# HISTORIC AND DESIGN REVIEW COMMISSION

**HDRC CASE NO:** 2021-027  
**ADDRESS:** 520 LEIGH ST  
**LEGAL DESCRIPTION:** NCB 2739 BLK LOT 4F & PT OF 5F (AKA TRACT 6)  
**ZONING:** IDZ,H  
**CITY COUNCIL DIST.:** 1  
**DISTRICT:** Lavaca Historic District  
**APPLICANT:** San Antonio San Antonio/LABOR STREET COMMONS LLC  
**OWNER:** San Antonio San Antonio/LABOR STREET COMMONS LLC  
**TYPE OF WORK:** Construction of a 2-story residential structure, site modifications  
**APPLICATION RECEIVED:** January 15, 2021  
**60-DAY REVIEW:** Not applicable due to City Council Emergency Orders  
**CASE MANAGER:** Stephanie Phillips

The applicant is requesting final approval to construct a new 2-story single family residence at the lot addressed 520 Leigh St.

A2.0 ELEVATIONS  
Scale 3/16" = 1'-0"

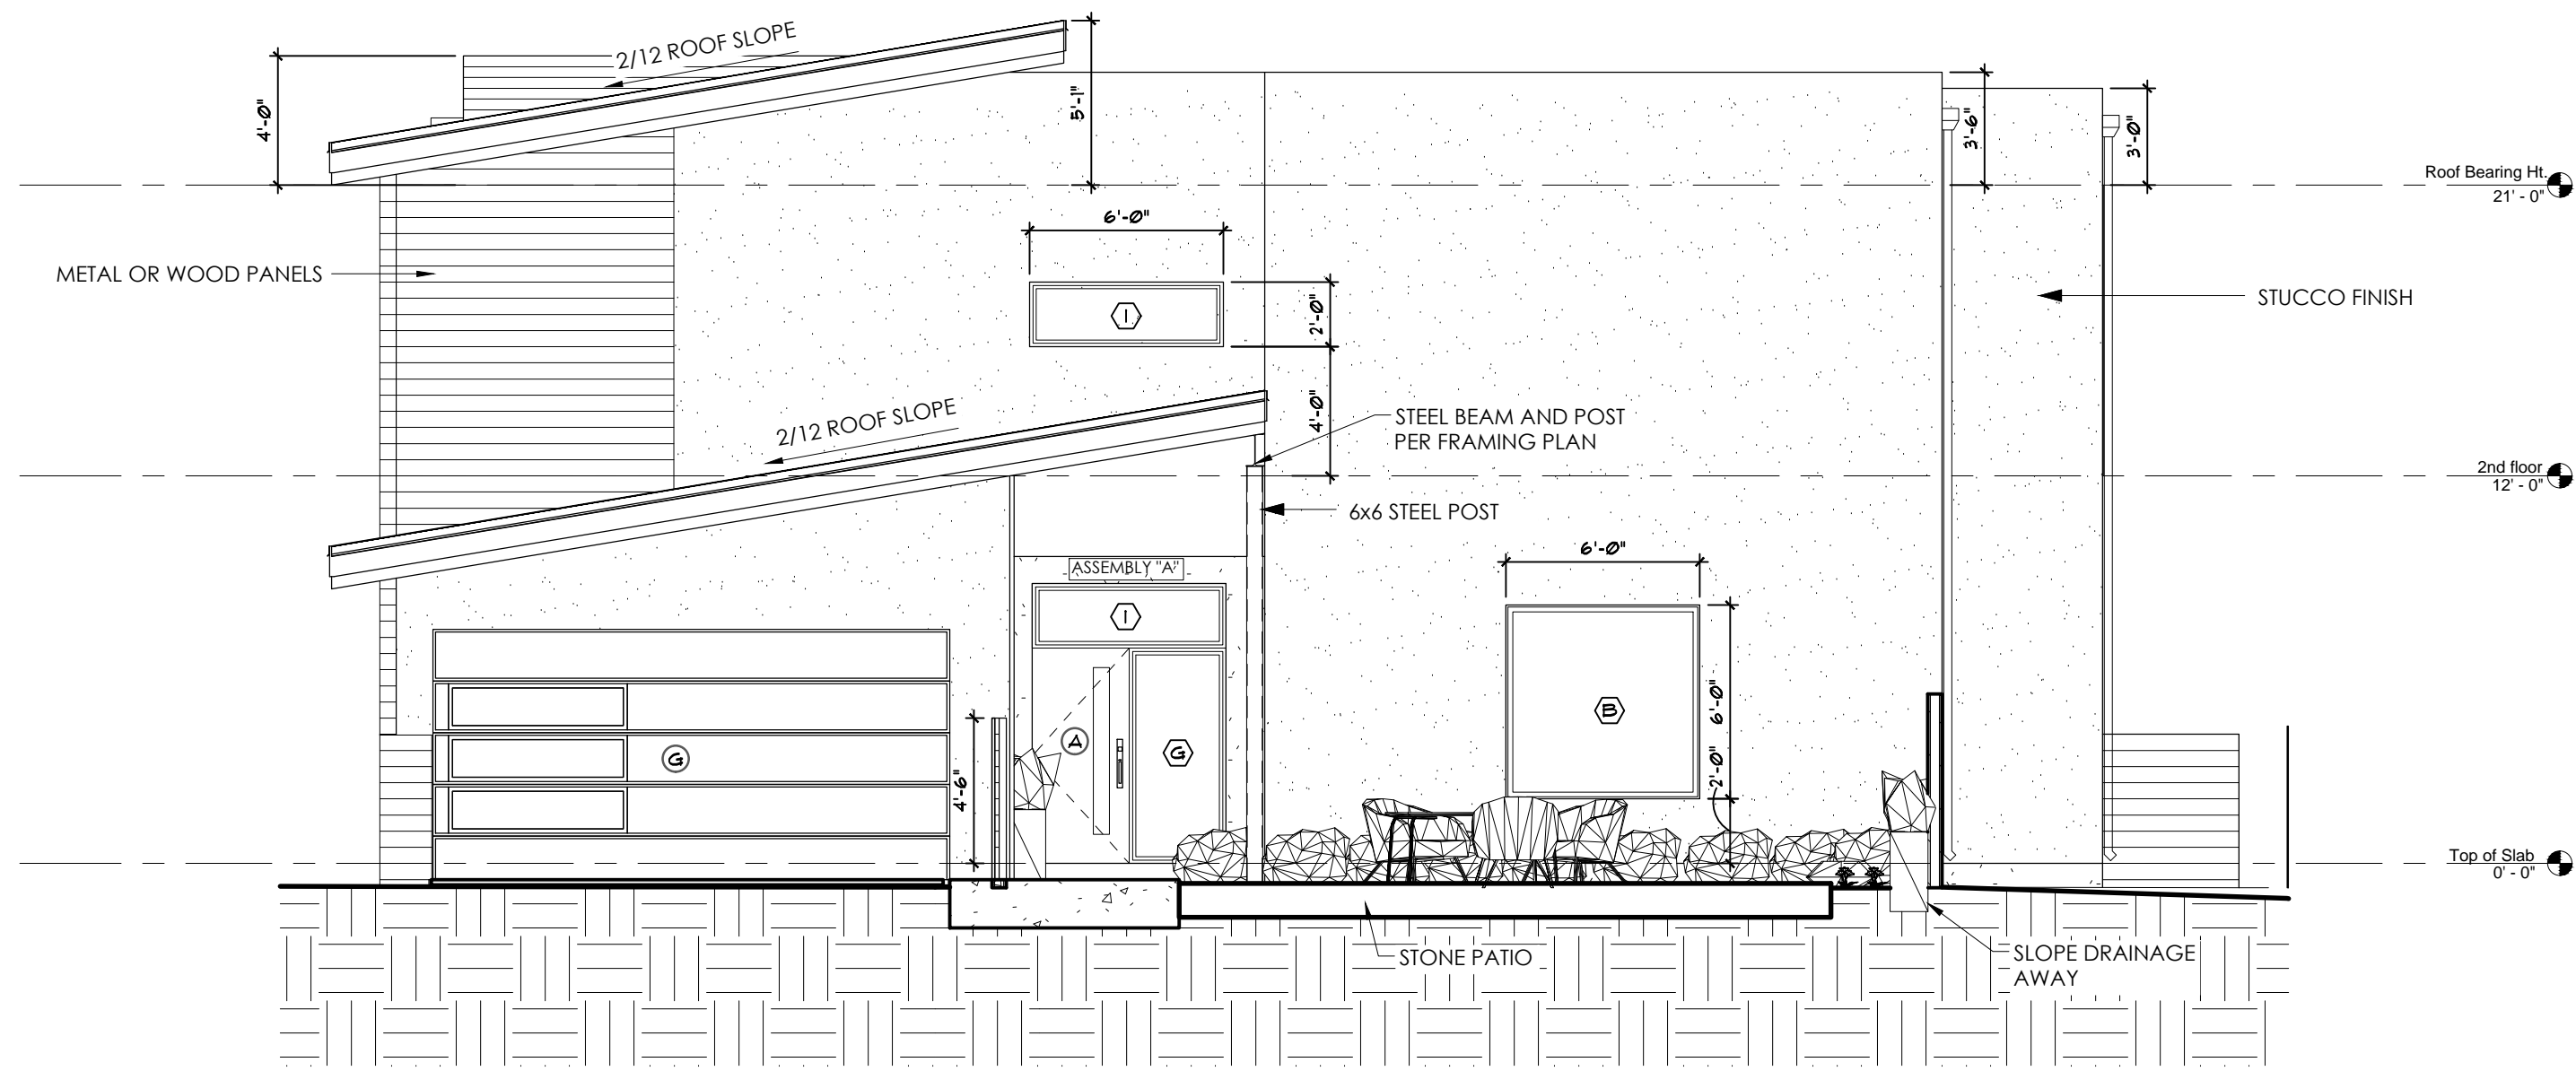
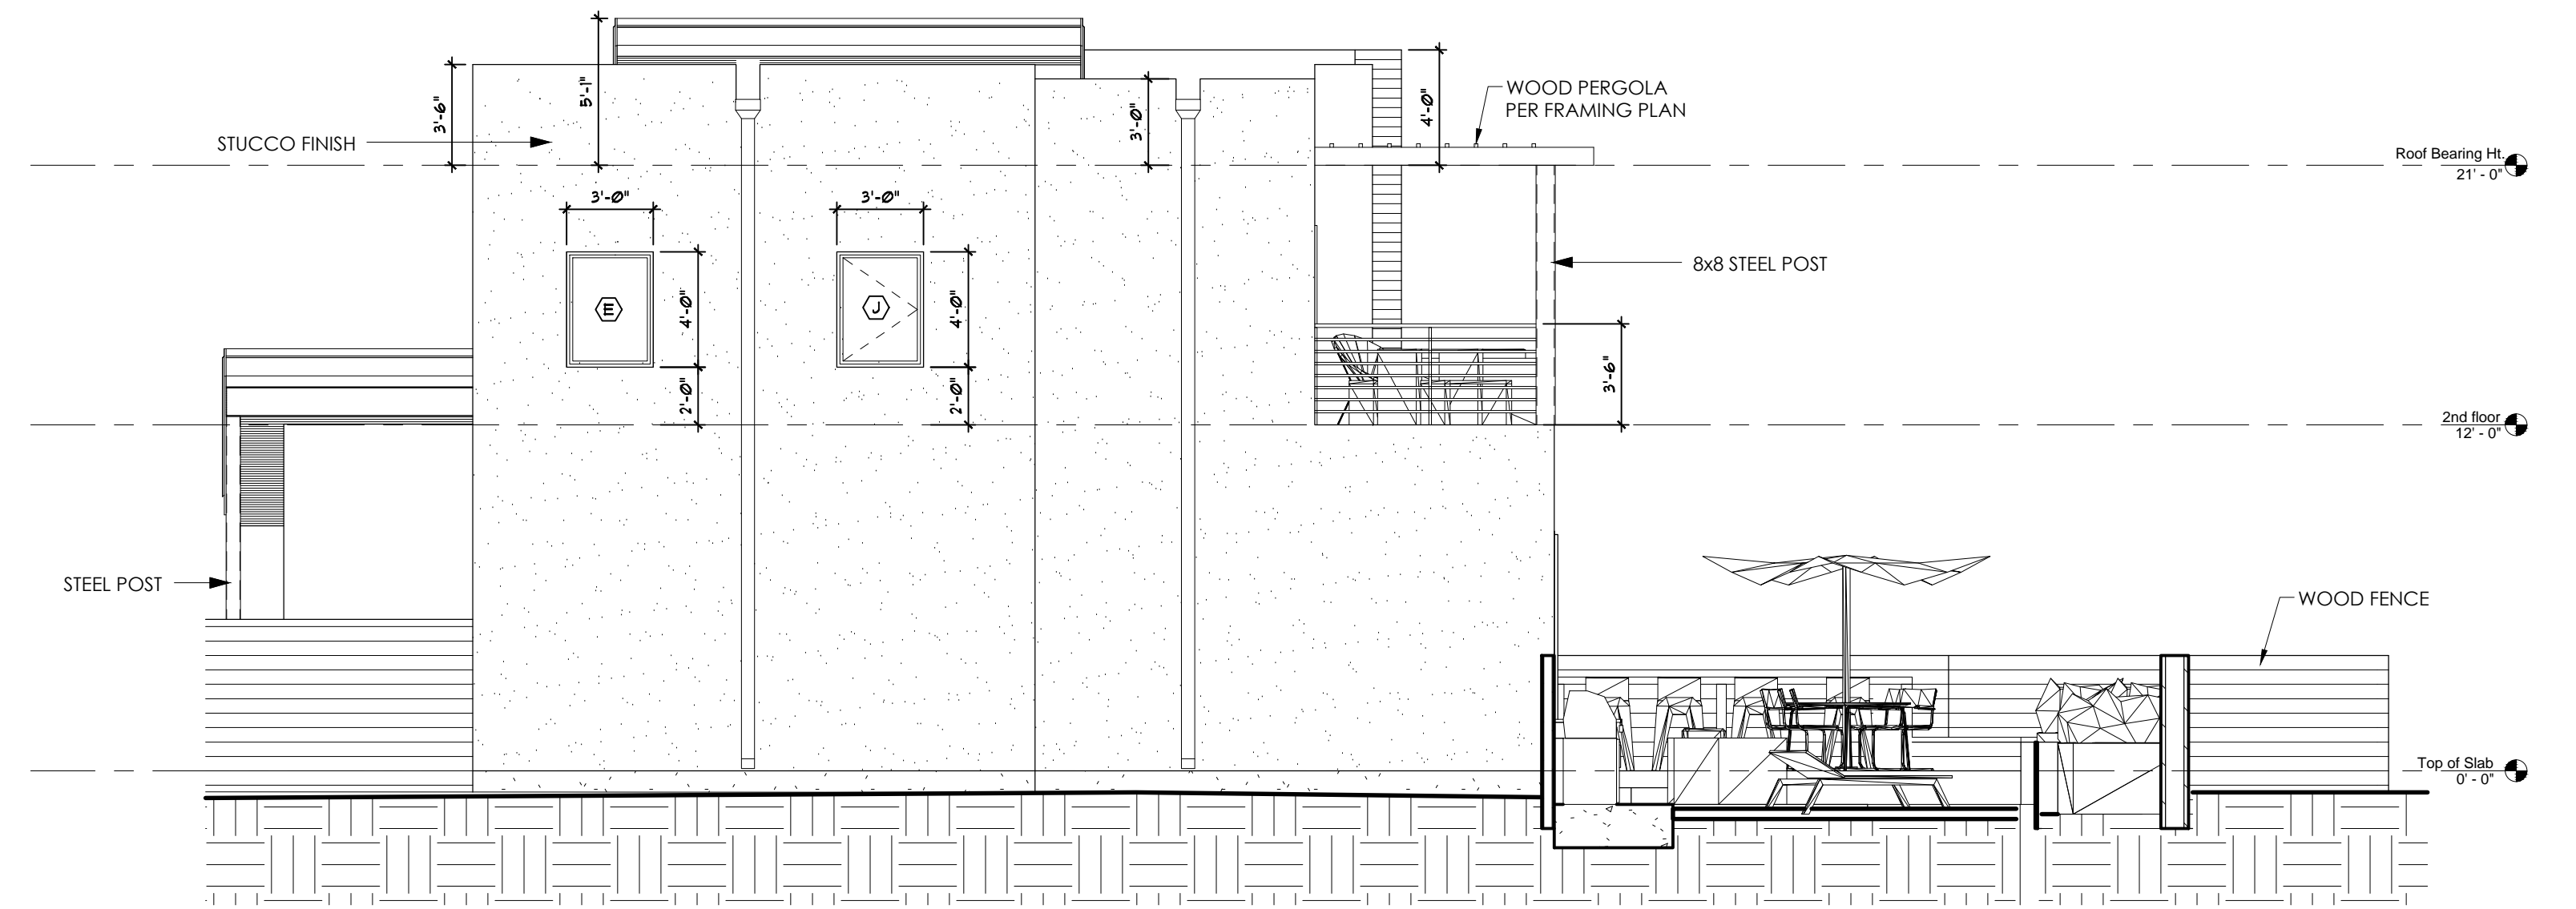
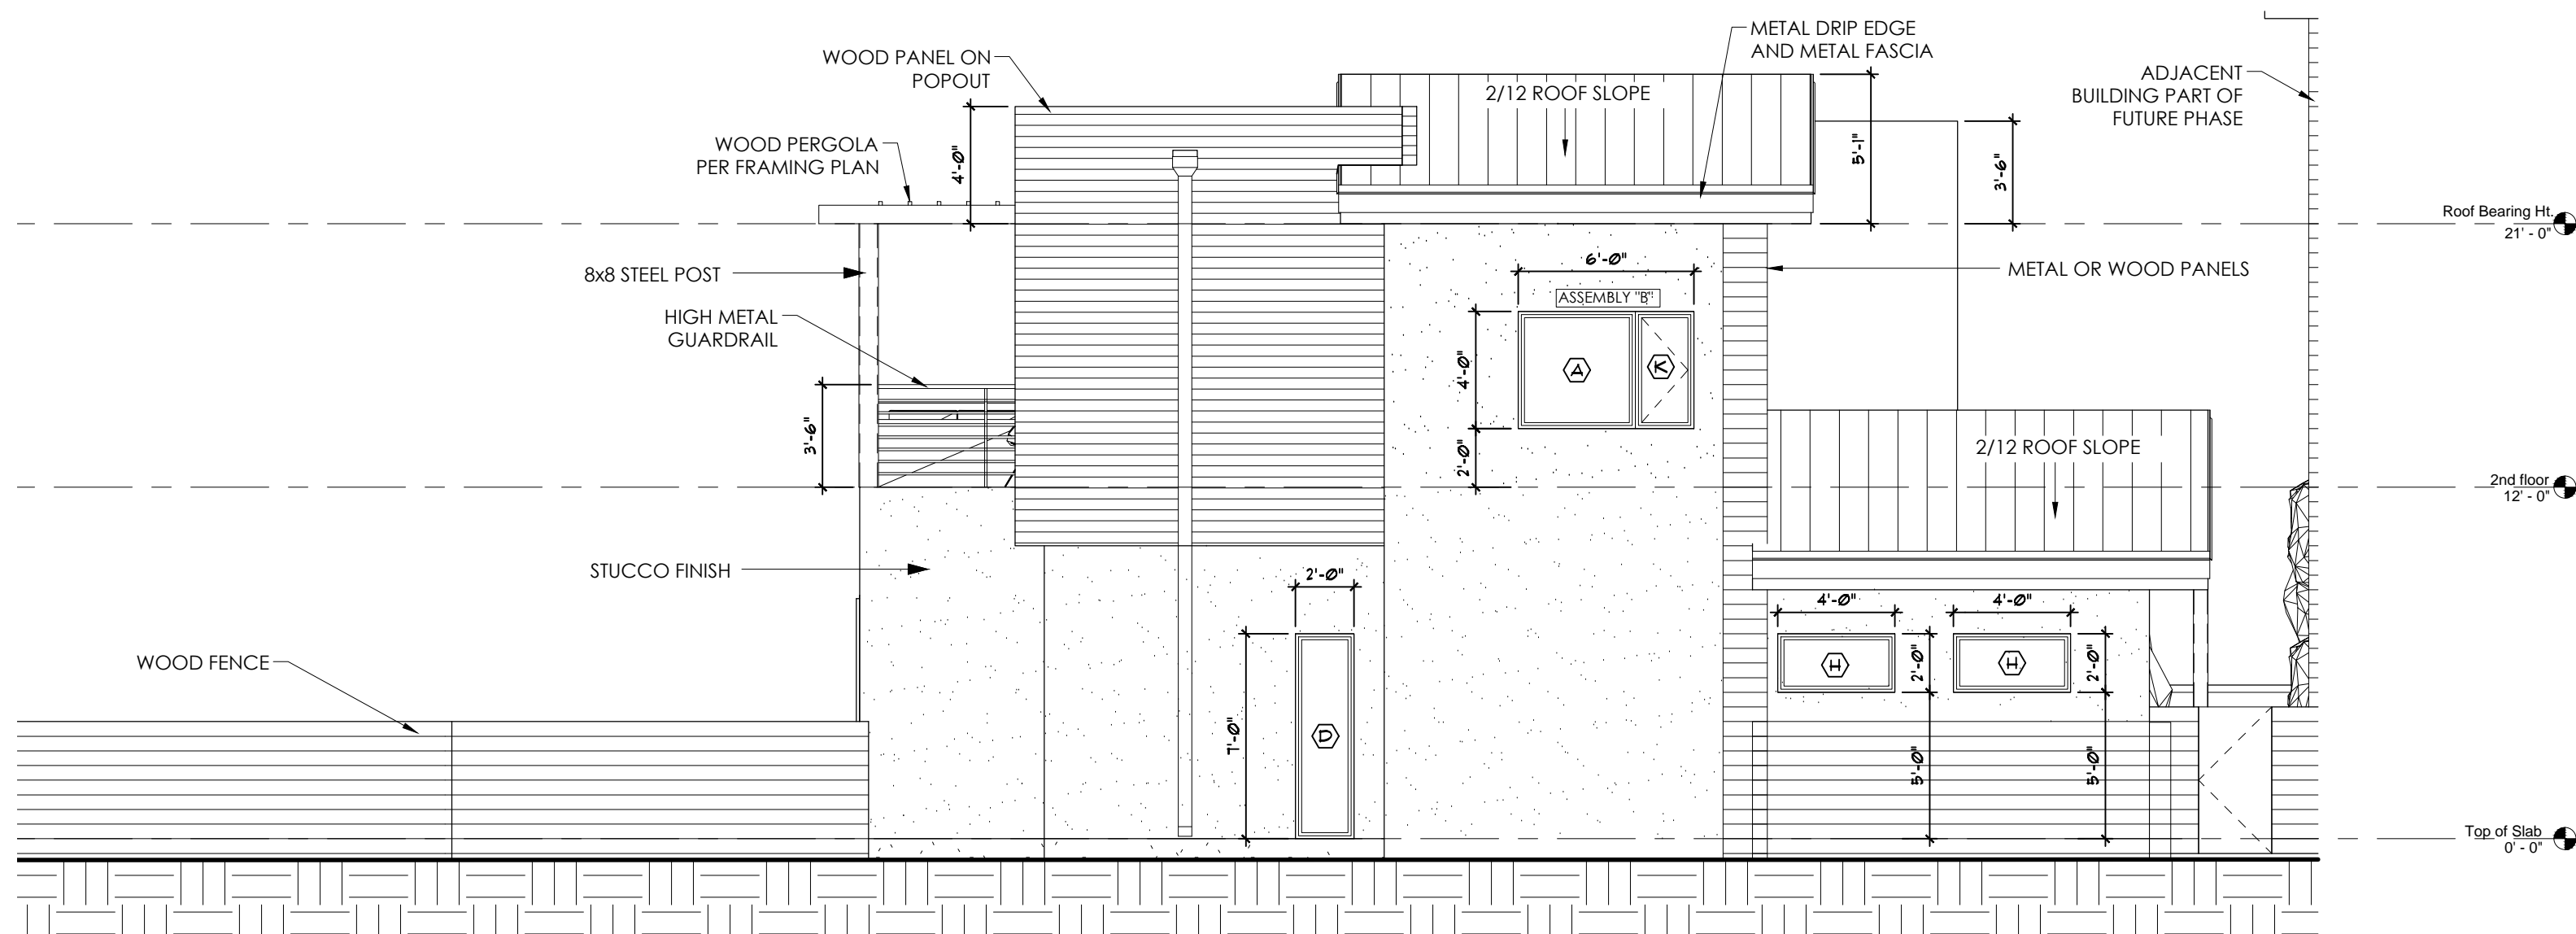
- f. **SCALE & HEIGHT** – Per the Guidelines for New Construction 2.A.i., a height and massing similar to historic structures in the vicinity of the proposed new construction should be used. In residential districts, the height and scale of new construction should not exceed that of the majority of historic buildings by more than one-story. This block of Labor features a 3-story recently constructed structure immediately to the north, as well as multiple historic structures, both residential and commercial, most of which are 1-story. While the proposed height of the new construction may be consistent with the Guidelines given the existence of a two-story historic structure on the block, staff is concerned regarding the proposed proportions of the new construction relative to the development pattern of the lot, which originally featured 1-story structures.

- j. **ROOF FORMS** – The applicant has proposed a multi-slope roofline. The primary roofline will feature a short parapet which will visually read as flat from the public right-of-way with low-sloping shed roofs concealed in the center. A portion of the roof will also feature sheds on the north elevation. Staff generally finds these roof forms to be consistent based on the surrounding context, but finds that in context with the proportions of the home, additional roof solutions should be explored to visually reduce the mass of the flat roof portion, primarily on the north and east elevations.

- k. **WINDOW & DOOR OPENINGS** – Per the Guidelines for New Construction 2.C.i., window and door openings with similar proportions of wall to window space as typical with nearby historic facades should be incorporated into new construction. Per the elevations that the applicant has submitted, staff finds the proposed windows to be inconsistent with the Guidelines. The proposed sizes, configurations, and rhythm are not found historically within the district.

- l. **PORCH MASSING** – The applicant has proposed a front porch that consists of a stoop and roof element that is attached to the front façade of the historic structure. Porches found historically within the district feature massing that is incorporated into the massing of the structure, rather than simply attaching to the front façade,

particularly in the case of two story structures. Staff finds that the proposed porch massing should be incorporated into the overall design of the structure and feature porch configurations and details that are historically found in the district.

- ii. That the proposed structure be reduced in height and massing to be consistent with rear accessory structures found historically within the district (subordinate to primary structures), as noted in findings f and g.

- iii. That the applicant utilize foundation heights that are consistent with the Guidelines, as noted in finding i.
- iv. That the applicant incorporate roof forms that feature matching ridge lines as noted in finding j.

- v. That the applicant incorporate appropriate window sizes and proportions as noted in finding k.
- vi. That the applicant incorporate appropriate porch massing as noted in finding l.
